V2500-A5 PROPULSION SYSTEMS SERVICE BULLETIN

This document transmits the Initial Issue of Service Bulletin V2500-ENG-73-0227 and the Revision 1 of Hamilton Sundstrand Service Bulletin EEC150-40-73-28.

ENGINE – FUEL AND CONTROL – CONTROL, ELECTRONIC ENGINE – REPLACEMENT OF THE TRANSIENT
VOLTAGE SUPPRESSORS

ENGINE FUEL AND CONTROL - EEC150-40 ELECTRONIC ENGINE CONTROL - TRANSIENT VOLTAGE SUPPRESSOR REPLACEMENT

LOCATION OF THE ELECTRONIC ENGINE CONTROL
73-22-34
FIGURE 1

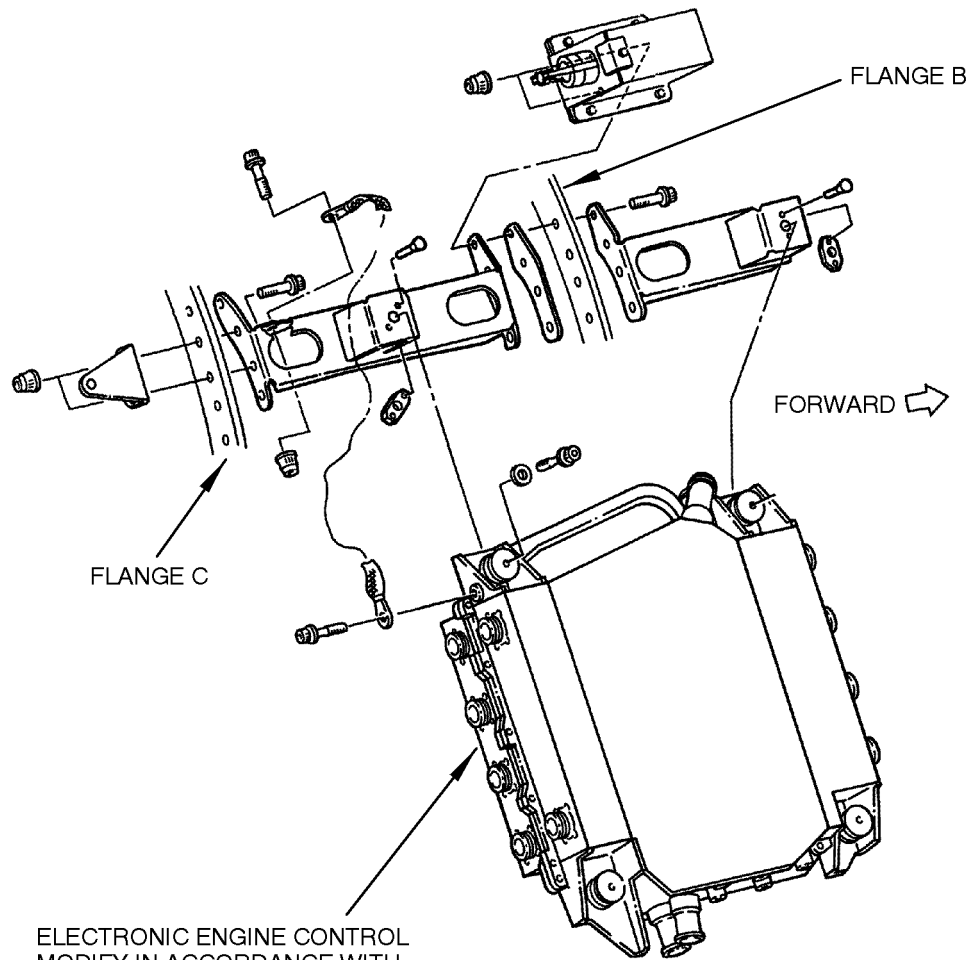
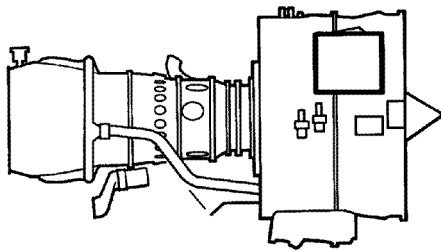
ELECTRONIC ENGINE CONTROL
MODIFY IN ACCORDANCE WITH
REFERENCE 1, HAMILTON SUNDSTRAND
SERVICE BULLETIN NO. EEC150-40-73-28

- (1) Modify your Electronic Engine Control (EEC) in accordance with Reference 1, Hamilton Sundstrand Service Bulletin No. EEC150-40-73-28. See Figure 1 for the location of the EEC.
- (2) Recording Instructions
 - (a) A record of accomplishment is required.
